SAS SUPERSTRUCTURE - CONDUIT AND CABLE TRAY PLAN

CONTRACT CHANGE ORDER NO. _____
 SHEET _____ OF _____

SAS SUPERSTRUCTURE GIRDER WESTBOUND LIGHTING AND ELECTRICAL SYSTEMS

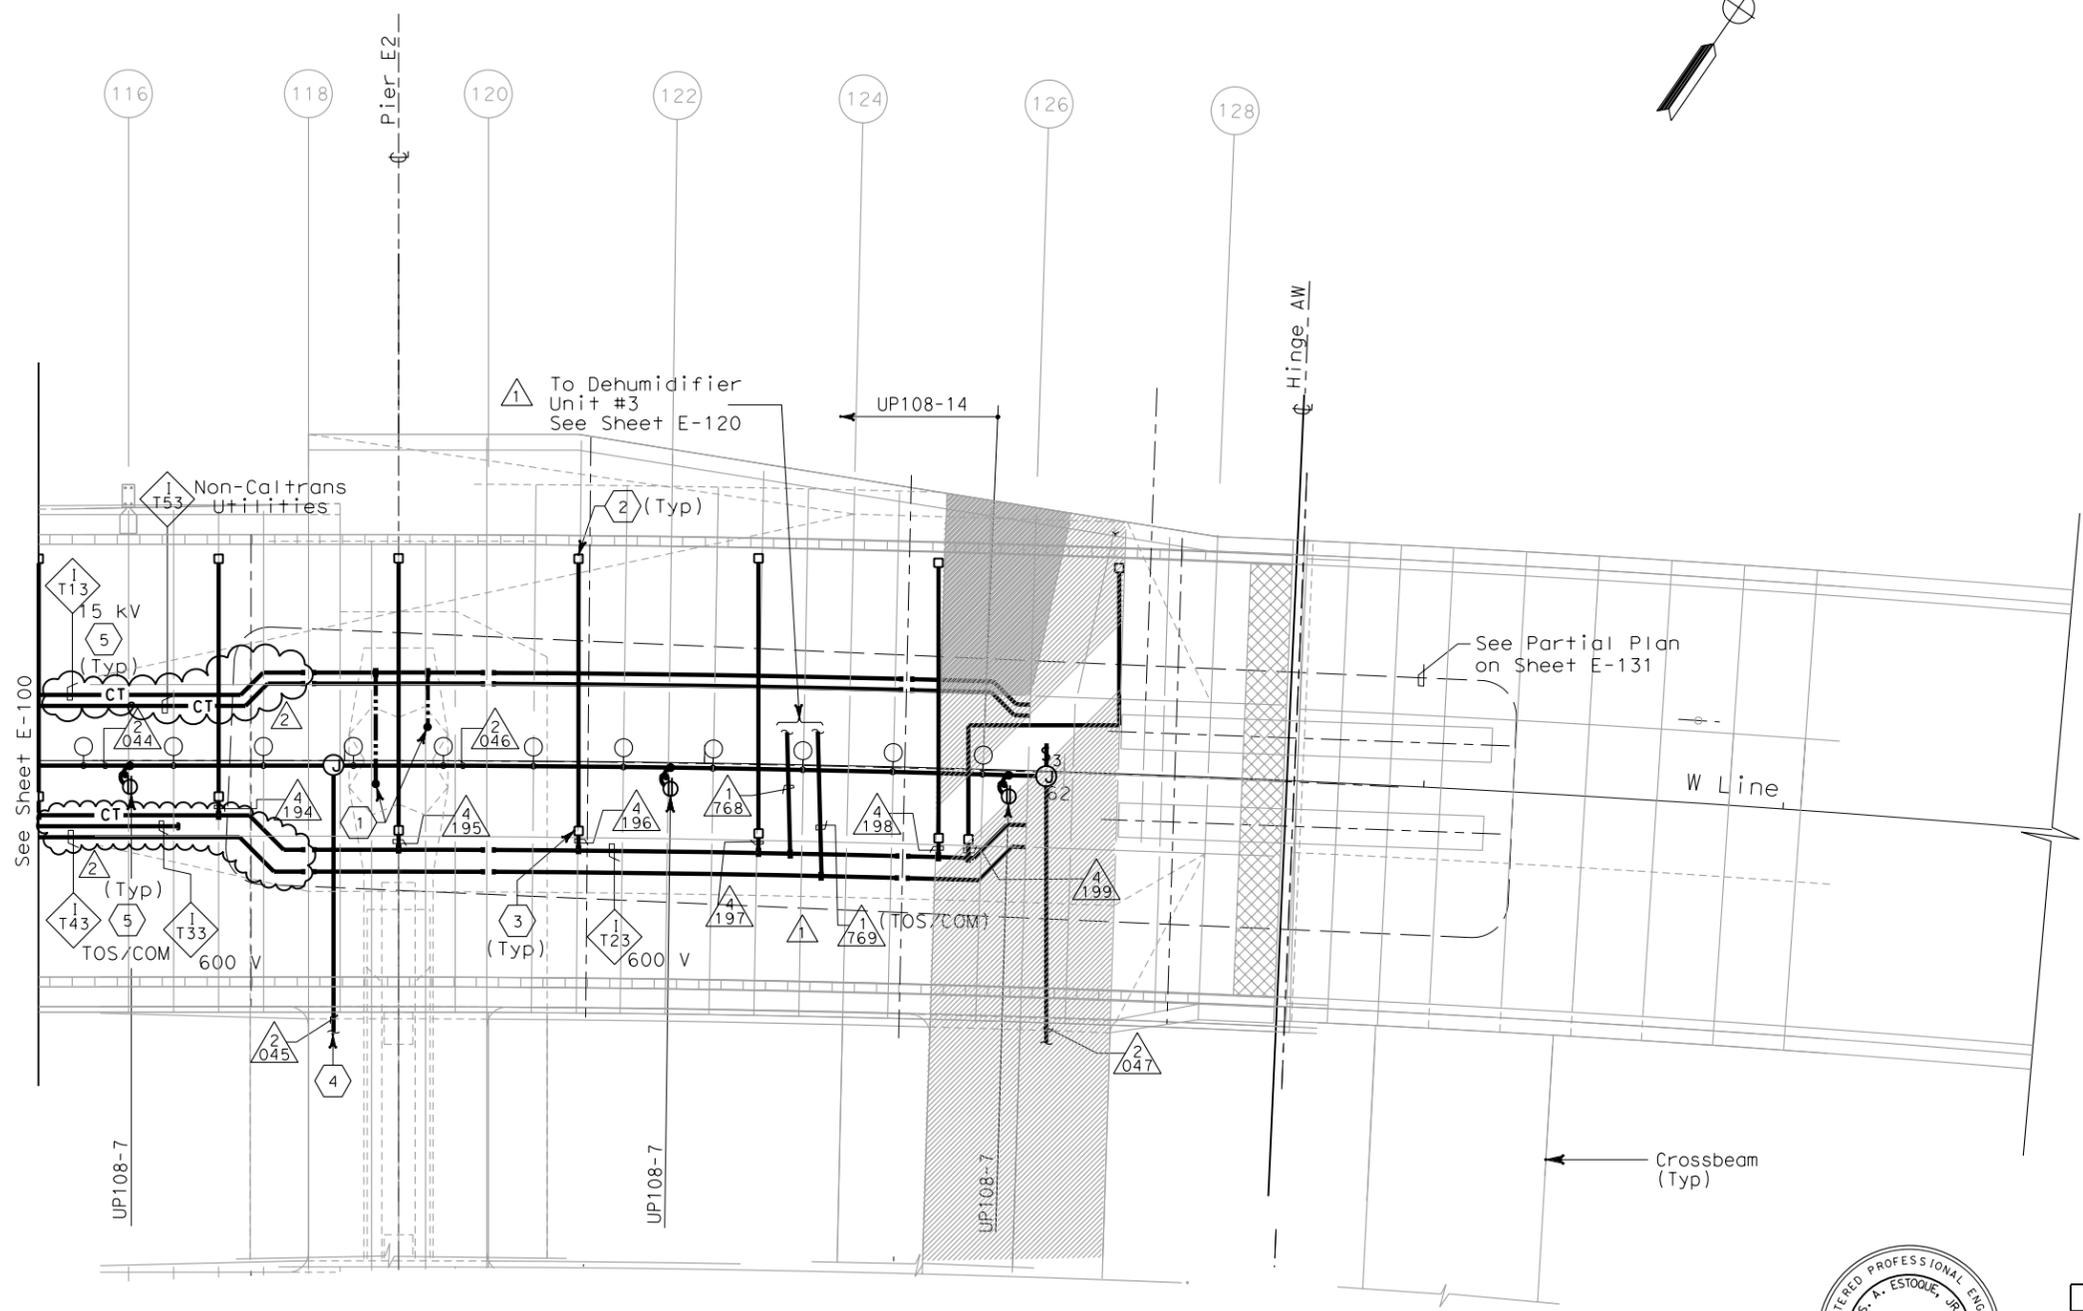
REQUEST FOR INFORMATION NOT ADDRESSED IN THIS CCO REMAIN IN FORCE					
MARK	DATE	DESCRIPTIONS	BY	CH'D	CCO#
2	02/25/08	CABLE TRAY CHANGES	MP	RG SE	42S1
1	02/19/08	ELECTRICAL MODIFICATIONS	MP	EL RR	42
